AGENDA  
PEACH BOTTOM ATOMIC POWER STATION, UNITS 2 AND 3  
LICENSE RENEWAL APPLICATION  
MONDAY, OCTOBER 22, 2001

# Peach Bottom Atomic Power Station

License Renewal Application

Scoping and Screening

Figure 2.1-1 - Scoping and Screening Process Overview

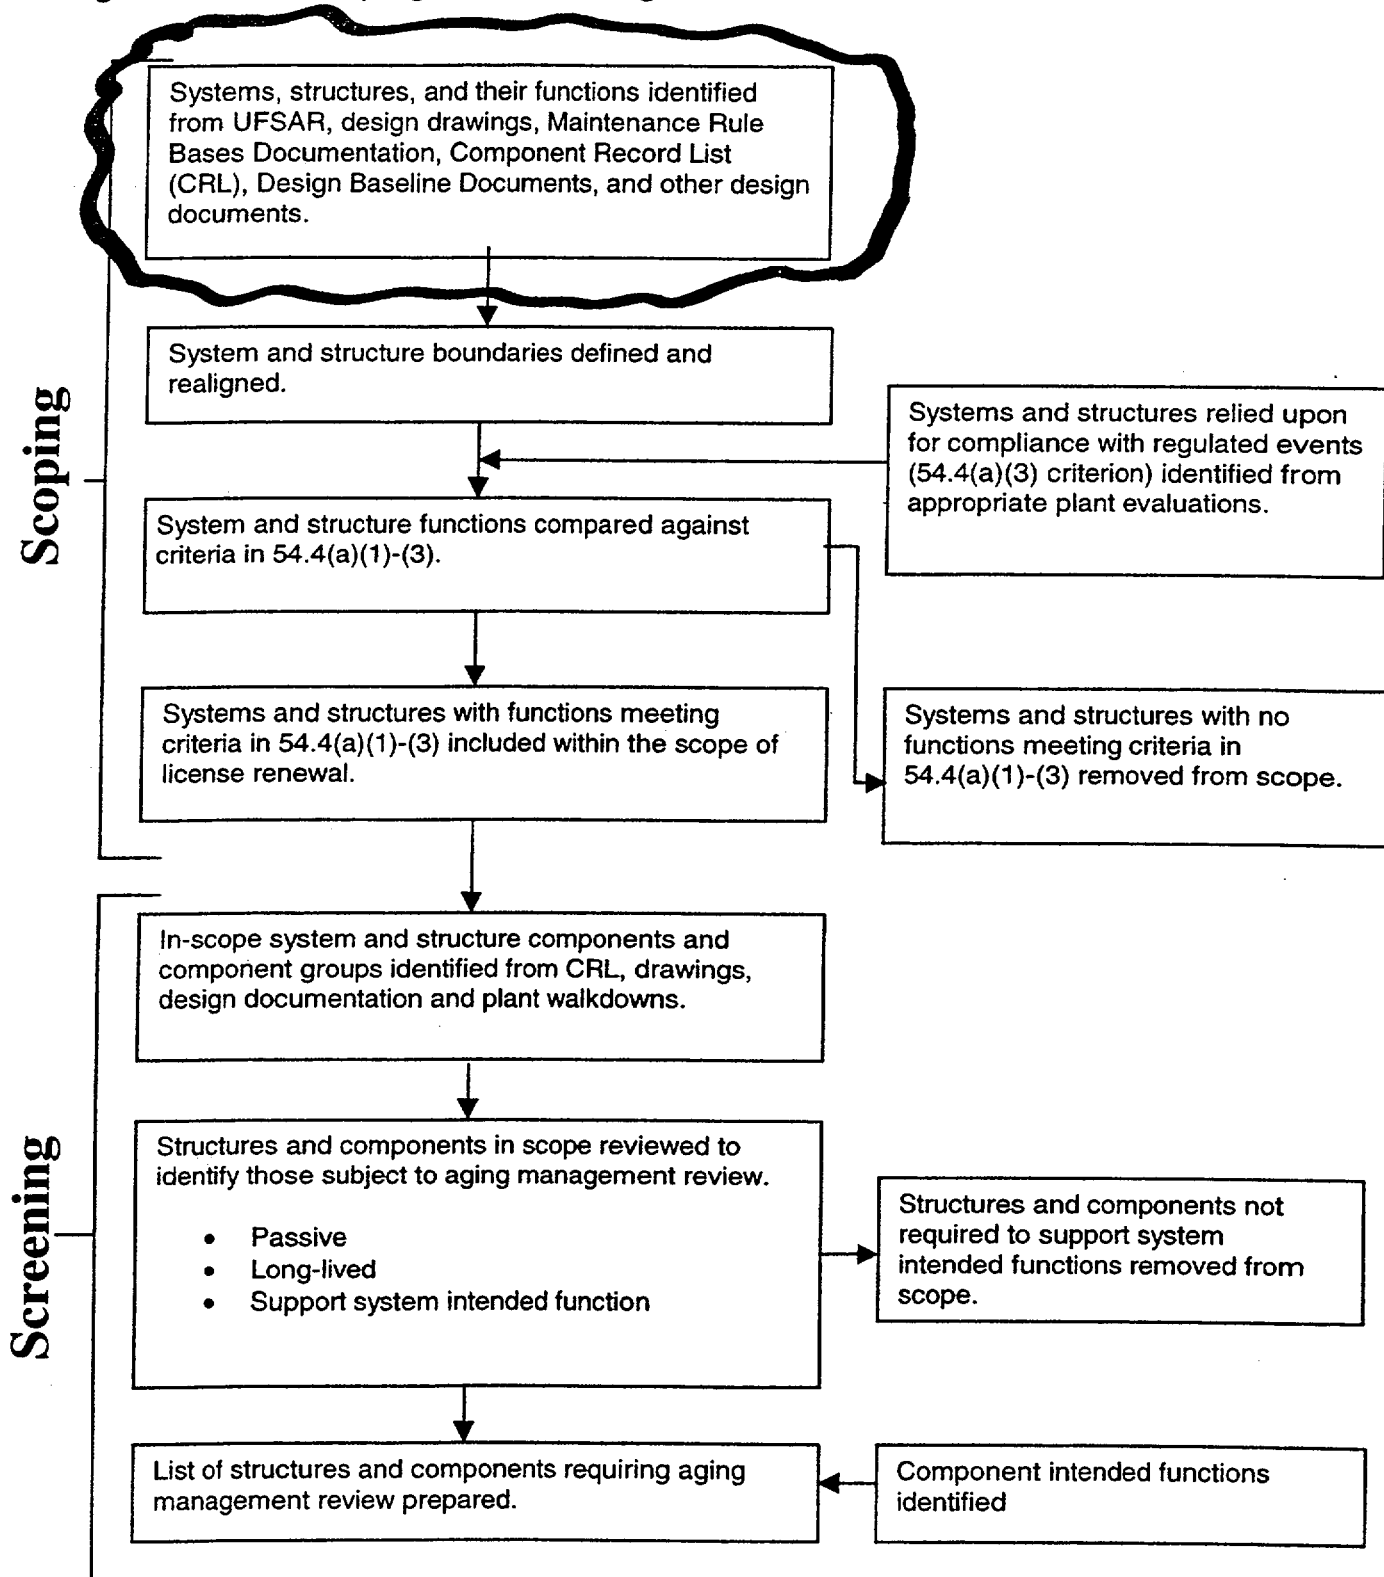
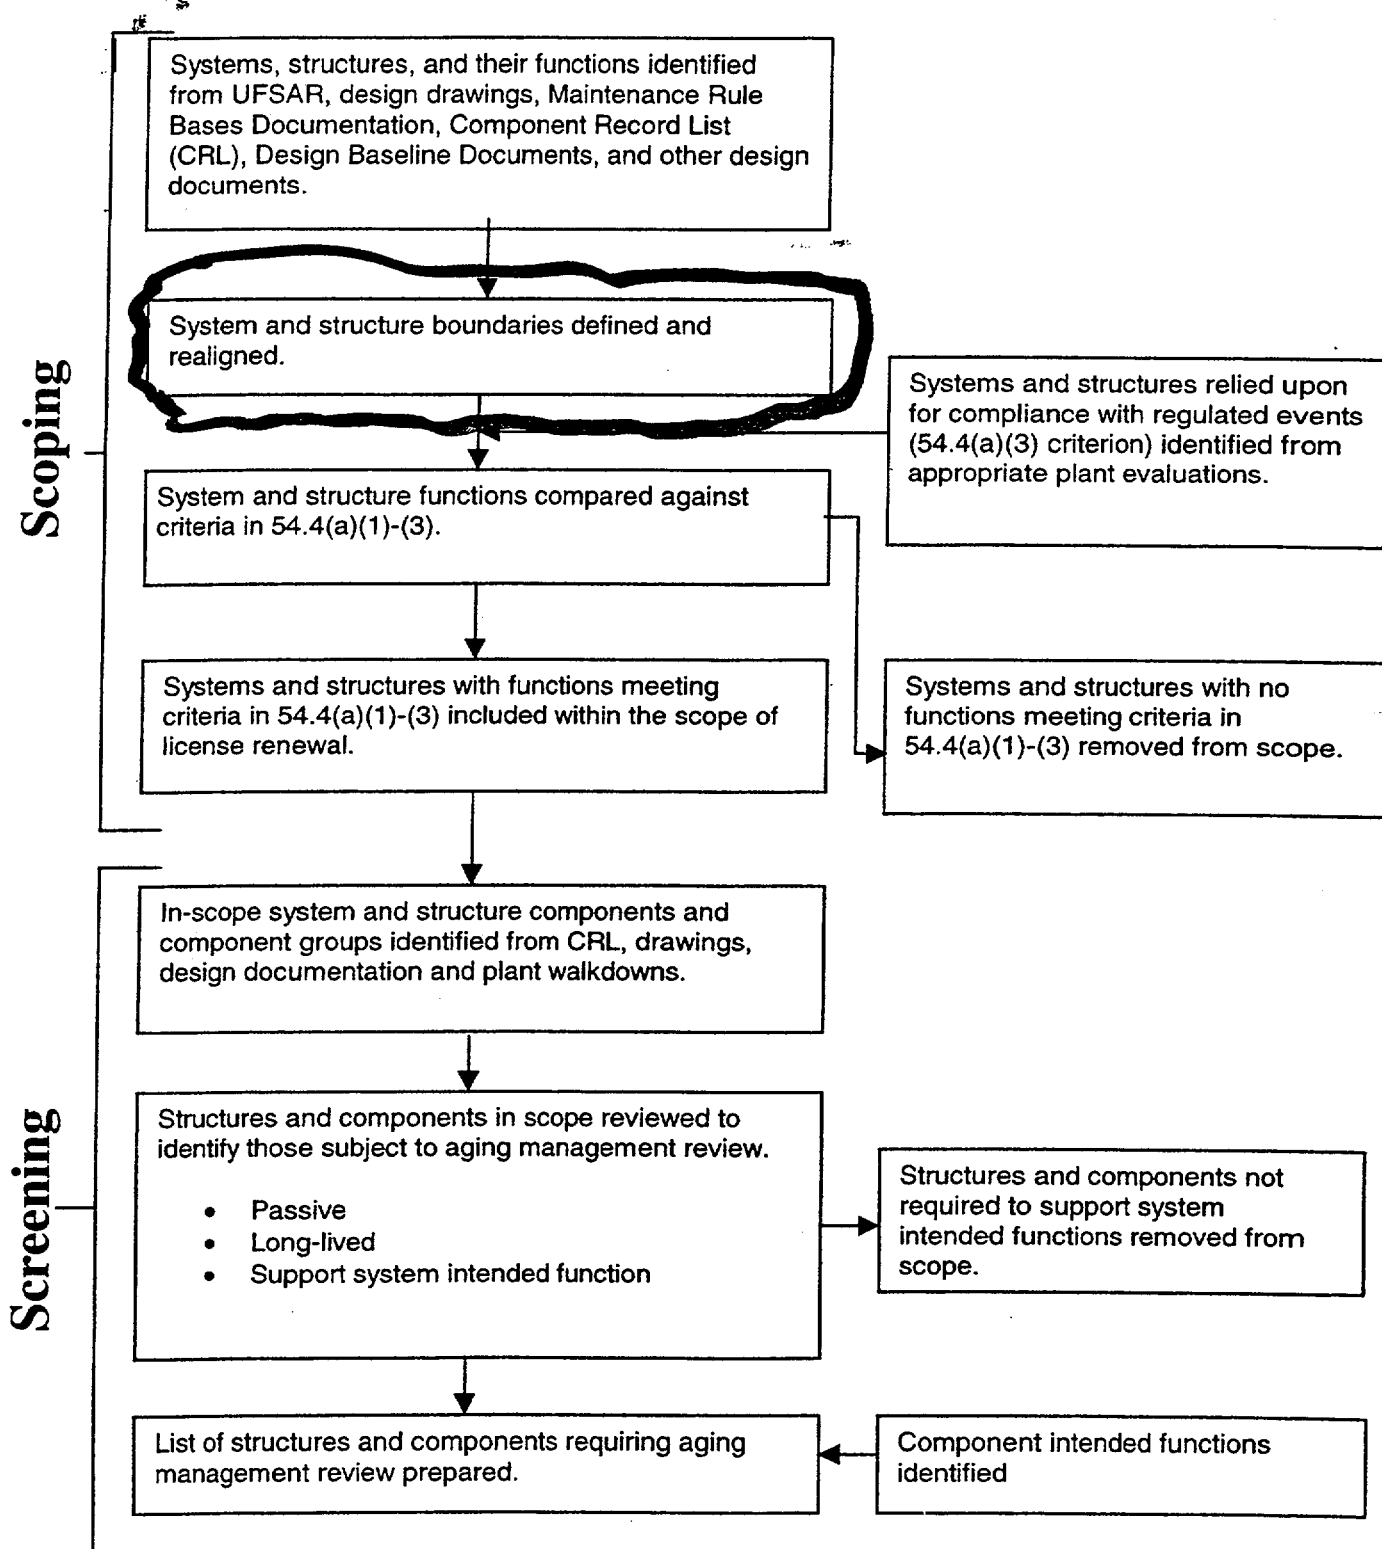
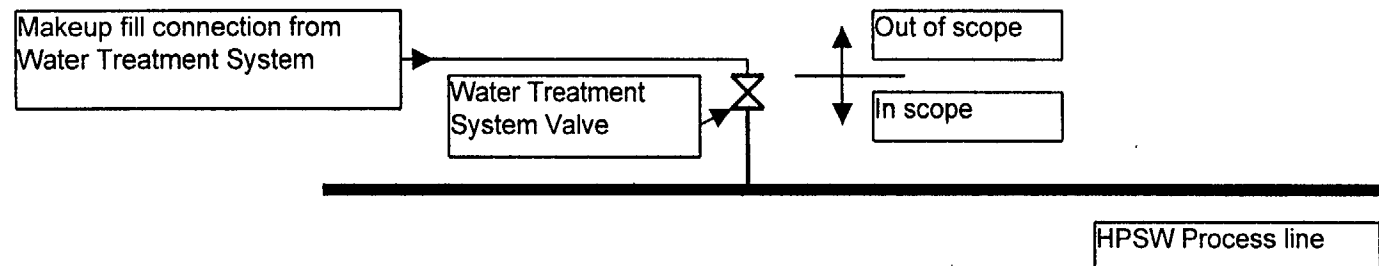
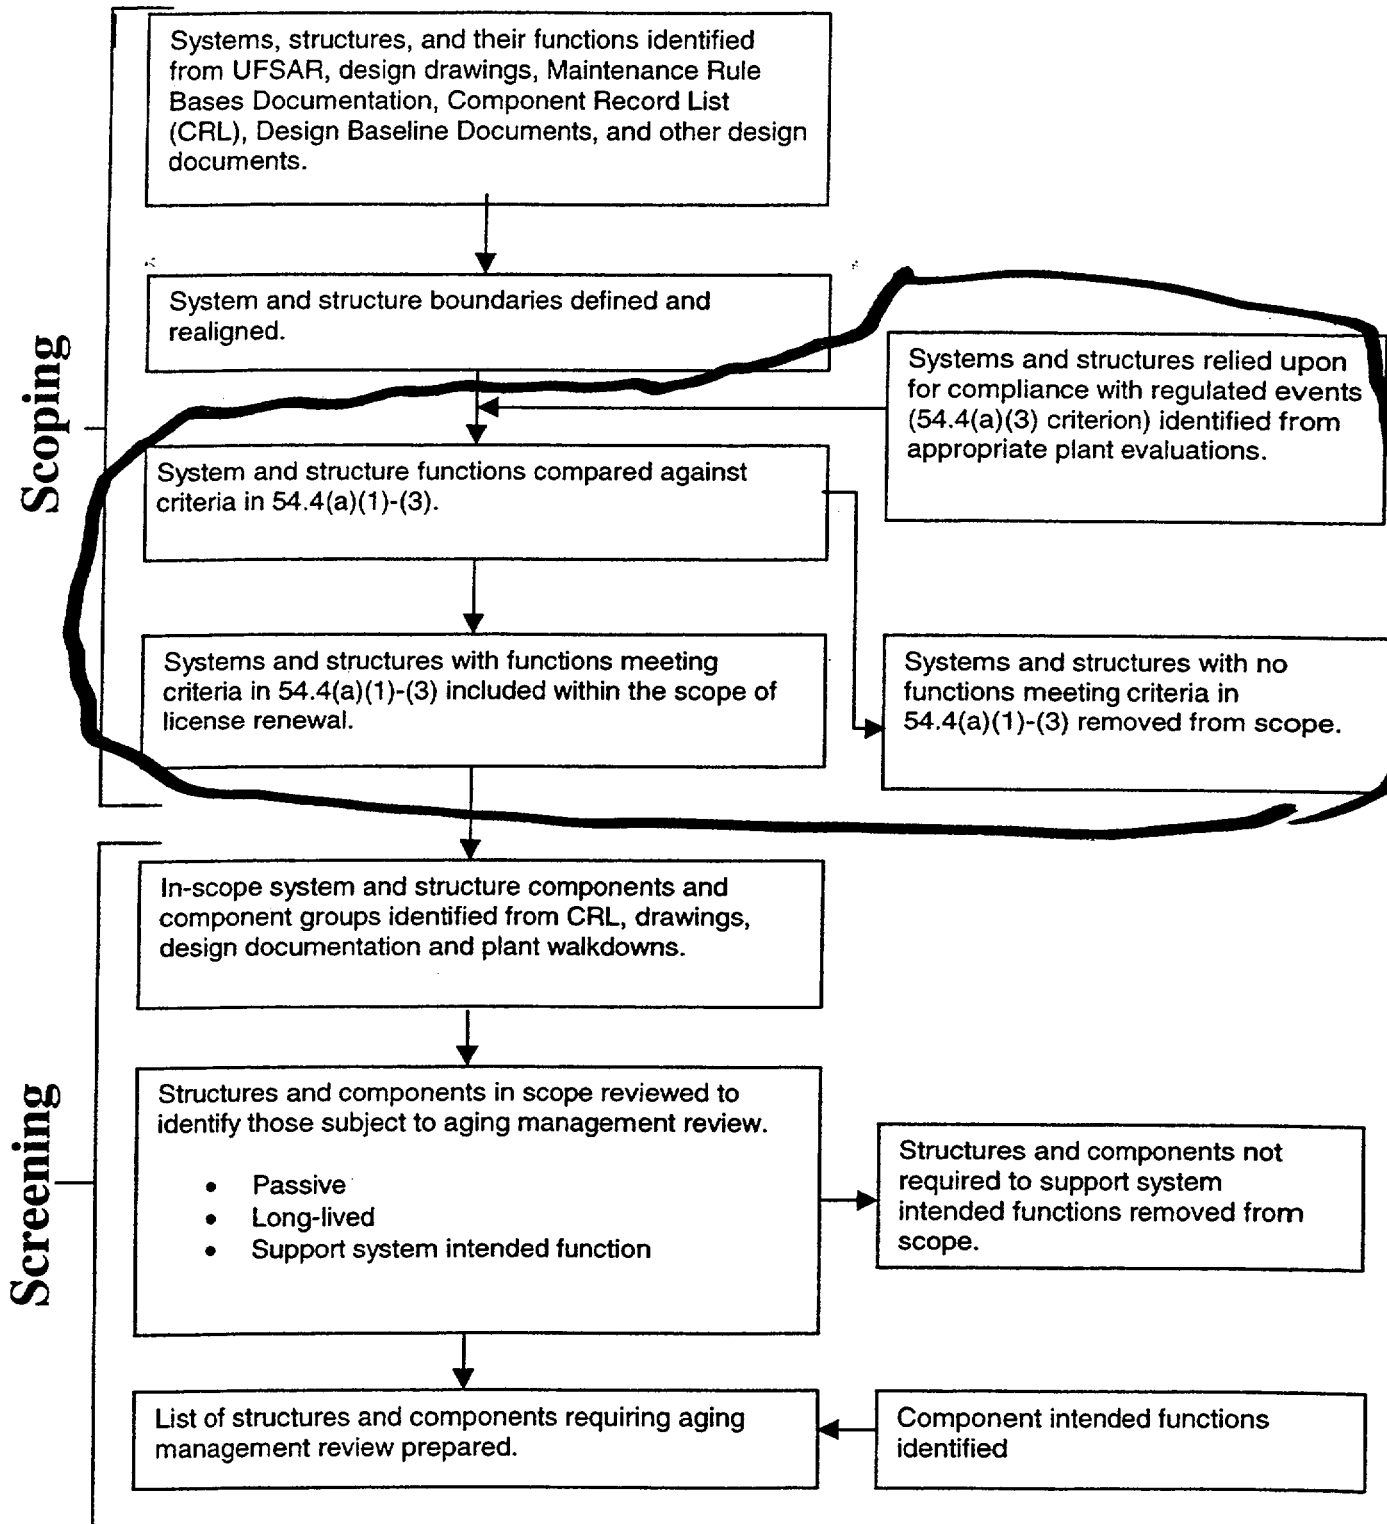
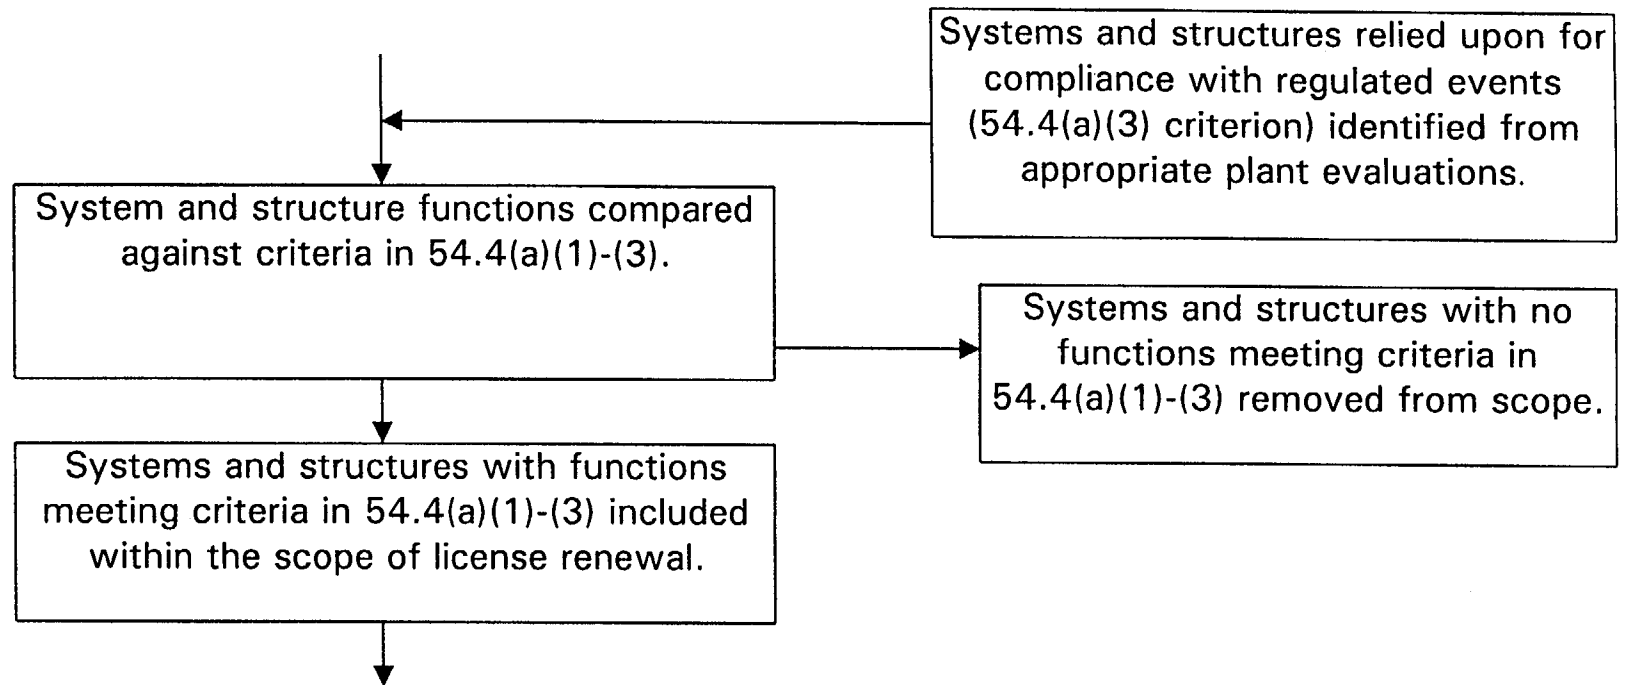
1	Introduction : Define the issues and expected outcome of the meeting.	NRC	9:00am
2	Clarify the scoping and screening process as shown in figure 2.1-1 of the PBLRA, as discussed at the meeting on 9/24/01, and explain how Exelon concluded that this process meets the requirements of 10 CFR 54.4 with respect to the following: <ul style="list-style-type: none"> <li>• System intended functions.</li> <li>• Explain the system realignment process and the rational for its use.</li> <li>• Determination of system/structure boundaries.</li> <li>• How the systems, structures and components reflected in the Peach Bottom current licensing basis [as defined by §54.3(a)] are captured in a consistent manner in the scoping process.</li> <li>• Explain the differences between the Component Record List and the UFSAR and how they are treated by the scoping process and reflected in the LRA.</li> </ul>	Exelon	9:15am

-Break-		10:45am
3	Discussion of NRC examples of apparent scoping inconsistencies and LRA clarity that could hamper the transparency of the review process: <ul style="list-style-type: none"> <li>• Reactor Water Cleanup (RWCU) System example is not in-scope (Fig 2.1-1 vs §54.4) but SCs of RWCU are in-scope per §54.21.</li> <li>• Given that system boundaries have been realigned for the PB LRA, how can the staff efficiently determine that all SCs are included in the Component Groups defined by the PBLRA?</li> </ul>	NRC	11:00am
	-Lunch-		12:00pm
4	Exelon to provide explanation for the specific examples in item 3 as to how the scoping and screening process was performed to ensure that SCs that need to be in scope of license renewal are captured in a consistent manner, in accordance with Part 54.	Exelon	1:00pm

- A comprehensive list of systems and structures to be evaluated for license renewal scoping was produced from the above documentation sources (LRA page 2-2, Section 2.1.2.1, first paragraph). These information sources are consistent with NUREG-1800 Standard Review Plan for License Renewal Table 2.1-1, and also Table 3.1-1 of NEI 95-10 revision 3, endorsed by Regulatory Guide 1.188:

- Component listings were downloaded from the CRL for each system.
- Component listings were used to mark-up P&ID drawings to establish in-scope system boundaries (LRA page 2-5).
- Some non-safety related systems at PBAPS include safety related components. For example, isolation valves in the makeup water fill connection to the safety related High Pressure Service Water (HPSW) system are safety related because they are part of the HPSW boundary. The makeup water connection is from the Water Treatment System, which is not safety related, but these individual isolation valves are safety related. Other examples are described on page 2-5 of the LRA, under the sub-heading of System Boundary Realignment.

- This is a general overview of the process of addressing the license renewal scoping criteria, which is described in detail in LRA pages 2-6 through 2-10.
- For systems, evaluation against criteria 54.4(a)(1) and (2) is based on Maintenance Rule program scoping documentation (LRA page 2-6 and 2-7).
- For structures, evaluation against criteria 54.4(a)(1) and (2) is based on review of UFSAR seismic classification (LRA pages 2-6 through 2-8).
- For systems and structures, evaluation against criteria 54.4(a)(3) is based on review of appropriate plant evaluations for the regulated events (page 2-9 and 2-10). License renewal position papers were prepared to identify specific systems credited for 10 CRF 50.48 (Fire Protection) and for 10 CFR 50.63 (Station Blackout).
- ATWS systems determined from CRL ATWS data field.

- Screening Methodology described in LRA Section 2.1.3, page 2-12 through 2-14.
- Final listing of in-scope components identified from previously downloaded component listings.
- Components entered into a License Renewal Database.
- Additional components not included in the CRL were identified and added to the database.

- Screening Methodology described in LRA Section 2.1.3, page 2-12 through 2-14.
- Component active versus passive determinations made in accordance with 10 CFR 54.21(a)(1)(i) and the guidance of NEI 95-10.
- Long-lived components identified in accordance with 10 CFR 54.21(a)(1)(ii) and the guidance of NEI 95-10.
- During this detailed component level review, any additional components identified that are not required to support a system intended function are removed from the scope of license renewal. Component listings (the license renewal database) and boundary drawings were updated as required.
- Intended functions identified for the structures and components requiring aging management review.

- Based on the above discussions regarding the scoping and screening process as outlined in Fig. 2.1- 1 and explained in the LRA sections 2.1.2 and 2.1.3, including the discussion on realignment, Exelon concluded that this process met the requirements of 10 CFR 54.4.
- Systems and structures with intended functions that need to be in the scope of license renewal were included in the application.
- Exelon hopes this presentation helps NRC understand how this process fulfills the requirements of 10 CFR 54.4.
